ACEA Comments to NL EFV guidance paper (April 6, 2009)

Figure 1: Issue of “ultimate” scaling in EFV concepts: no sufficient differentiation between existing vehicles

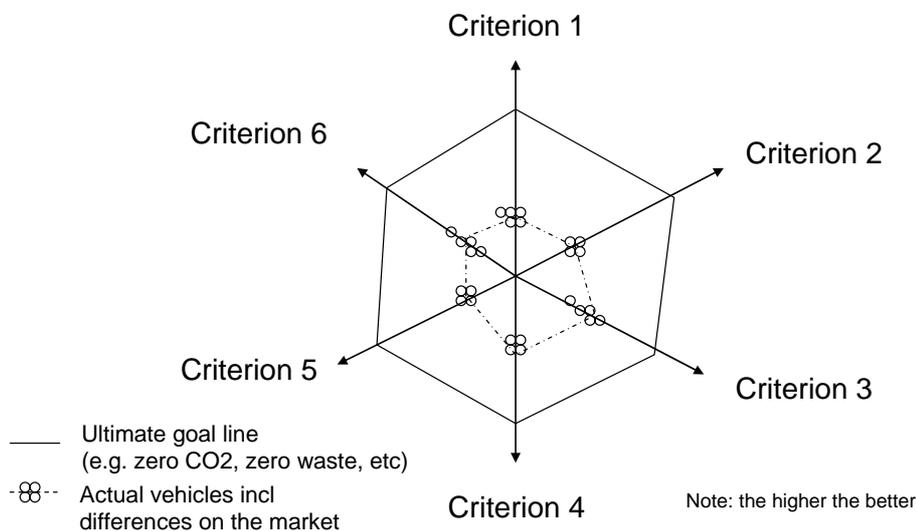
- Still regional differences remain: There is no world-wide or regional agreement on the long-term targets (e.g. for CO₂) nor an agreed comprehensive list of environmental dimensions.
- Not suitable for differentiation of current vehicles thus not suitable as an information system for governments or customers if the general distance to a long-term target is too big (all existing cars are in a close cloud around the current state of the technology – see figure).
- More suitable for developed countries
